Addendum 1

March 5, 2010

West Hancock High School Phase 2

Alvine No. 2009 0801

SCALE: 1/16" = 1'-0"
Reference Sheet A101
Sketch Number ADD#1-A1

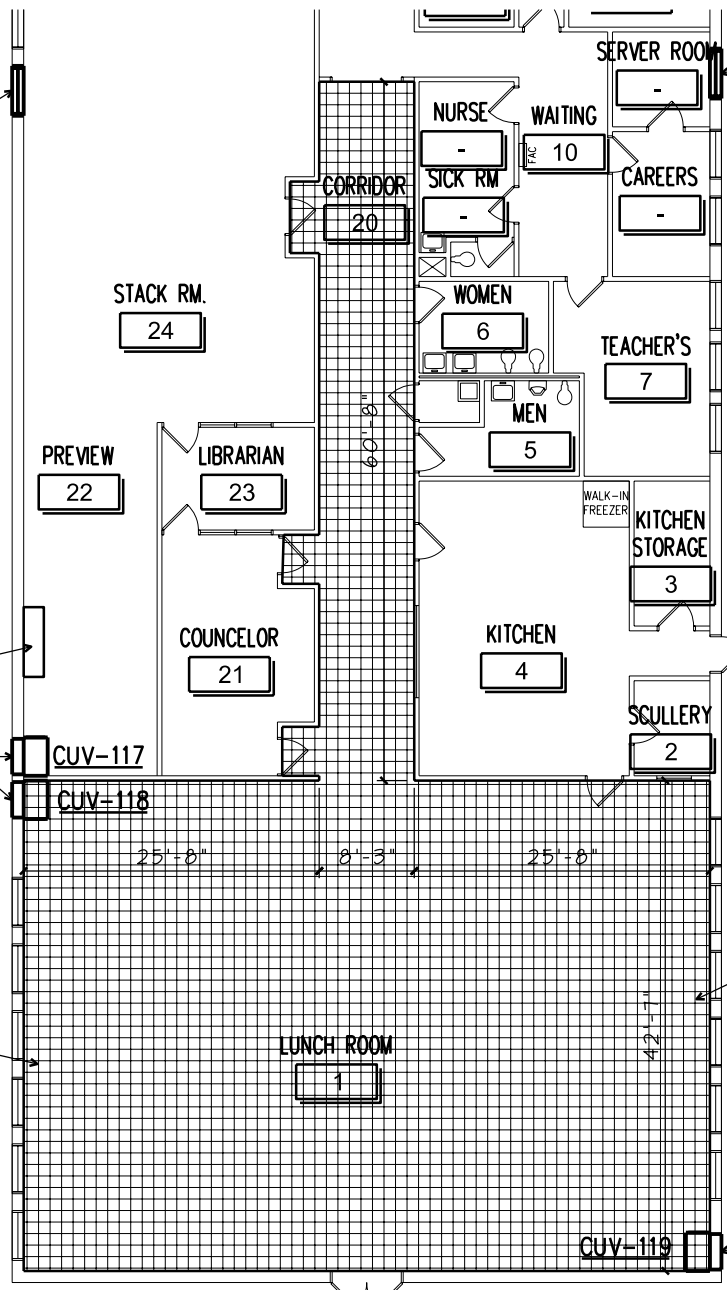
“PAINT WALLS AND ROOF STRUCTURE/DECK”
2. See the attached Sketch ADD#1-A1 for dimensions within the Lunch Room 1.
